To: Phil Tripp, Tripp Engineering
From: Brian Chambers, Senior Planner; 910.342.2782
CC: File;
Date: 5/12/2020
Re: Bradley Creek Station Revision 3 TRC Review 1

■ **BRADLEY CREEK STATION [TRC Plan Review #10]**

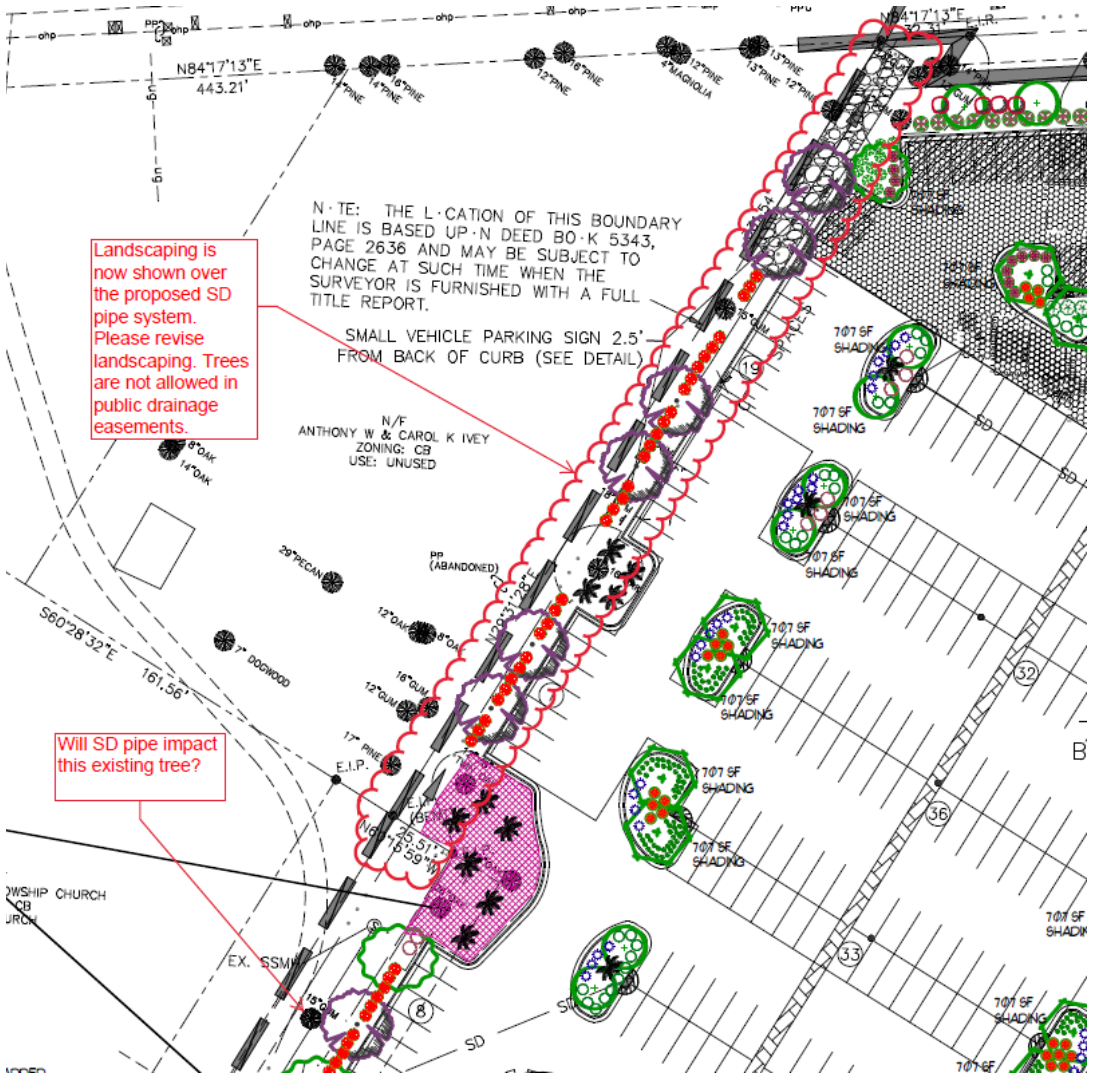
Landscaping is now shown over the proposed SD pipe system. Please revise landscaping. Trees are not allowed in public drainage easements.

Will SD pipe impact this existing tree?
